Recall Campaign Bulletin

Campaign No. 2024100006, October 2024

SUBJECT: **Model GLE (167 platform)**
Model Year 2021 – 2022

Check Acceleration Sensor Wiring Harness Routing

Figure 1

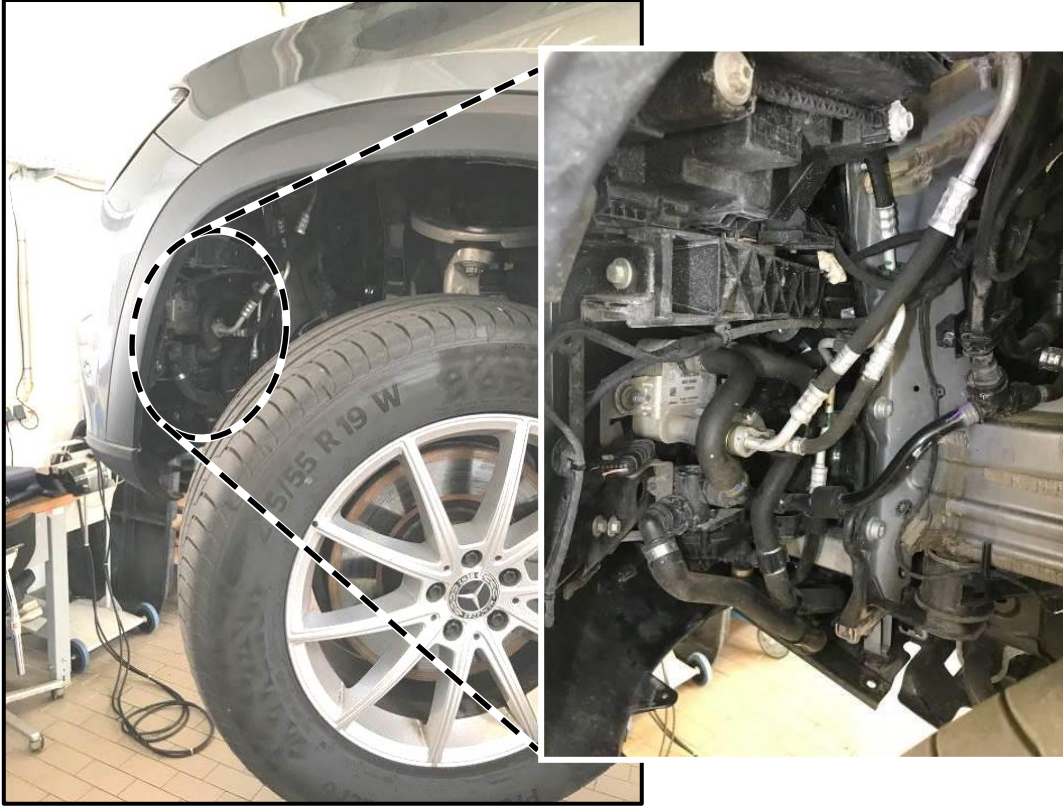
1. Remove front section from the front left fender liner.

Figure 2

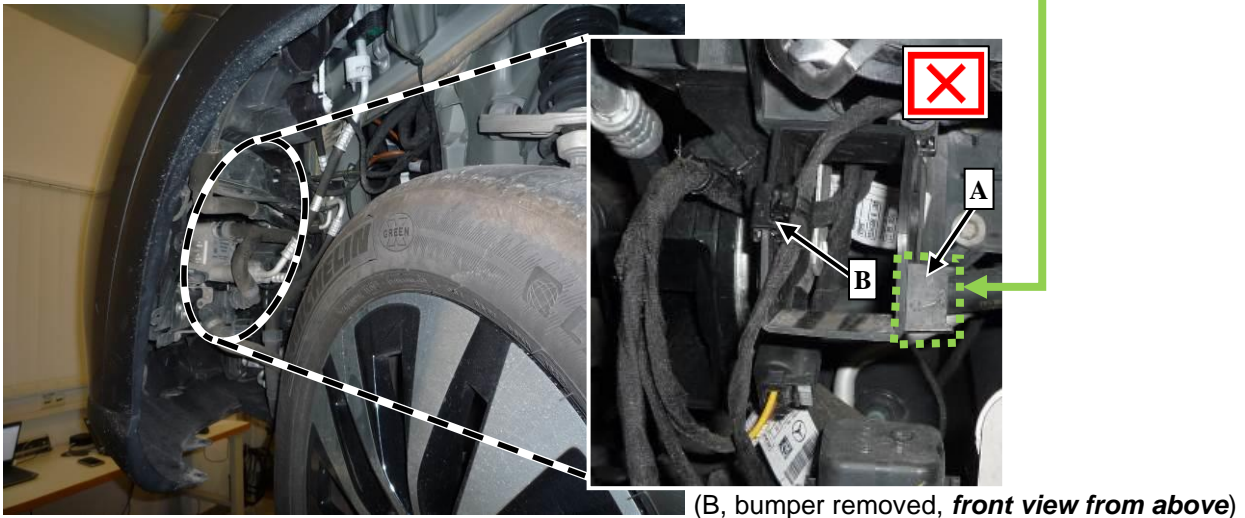
2. Check the wiring harness bracket (**Figure 2, A**) for the frontal acceleration sensor to ensure it is assembled correctly.

i Correct assembly position: (**Figure 2, A**).
 Incorrect assembly position: (**Figure 3, B**).

- a. Wiring harness bracket **correctly** (**Figure 2, A**) installed: **End measure**.
- b. Wiring harness bracket **incorrectly** (**Figure 3, B**) installed: Perform **Work Procedure**.

1. Remove front bumper.
i For basic data, see AR88.20-P-2000ME.
2. Fit wiring harness bracket correctly as shown (**Figure 2, A**).
i Wiring harness bracket is attached to the existing tab (**Figure 3, A**).
3. Assemble in reverse order.
